2AZ-FE & 2AZ-FXE Throttle Body

The purpose of this TSB is to provide updated throttle body part number information for certain vehicles equipped with the 2AZ-FE and 2AZ-FXE engine. The drain pipe has been eliminated on throttle body service parts. Please use the information below when replacing the throttle body assembly.

Figure 1. Previous Throttle Body Assembly

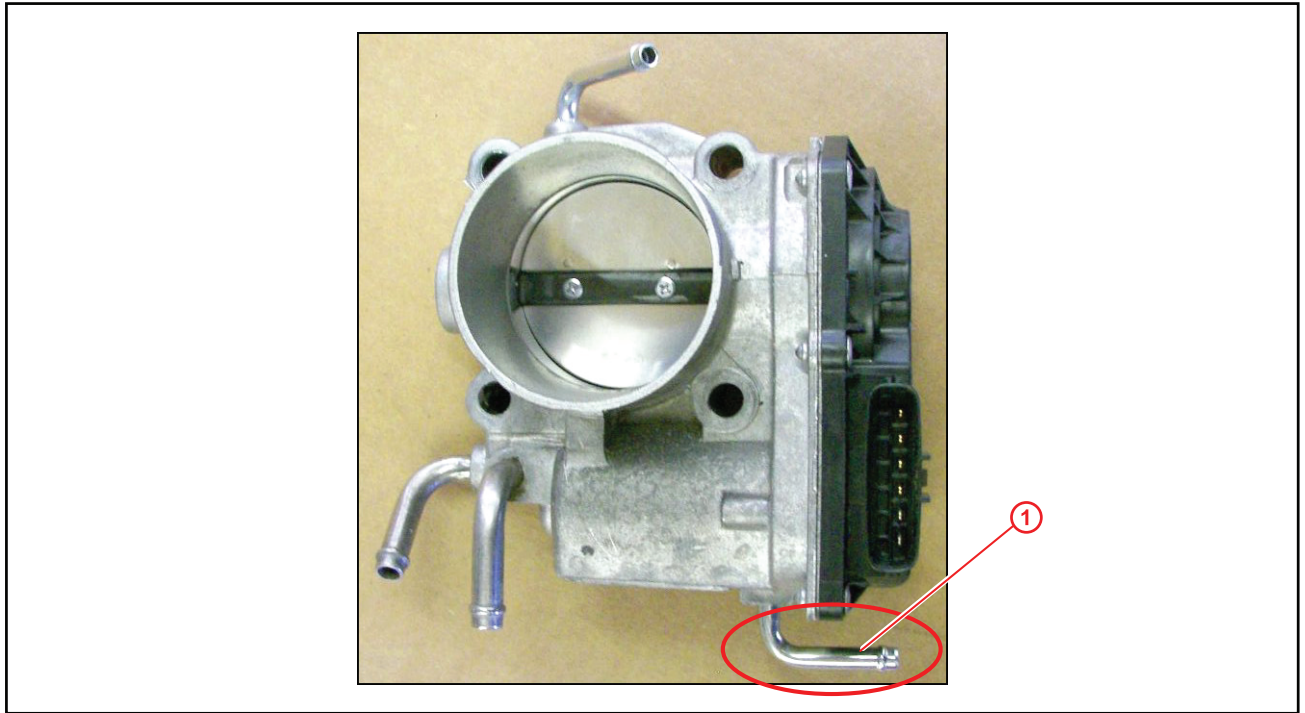
When replacing the throttle body assembly, remove and discard the throttle body hose that no longer has a port on the throttle body assembly. The port connected to the other end of the throttle body hose can be left open to the atmosphere — it does NOT need to be sealed.

This Port NOT on New Service Part
